# Broadacres Farm

## Town of Sudbury ADA Transition Plan

September 2020

Institute for Human Centered Design

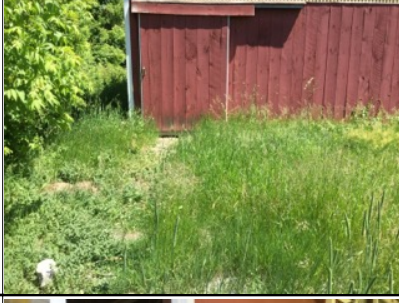
- See the following image for a recommendation on how to mark an accessible parking space in an unpaved parking lot:
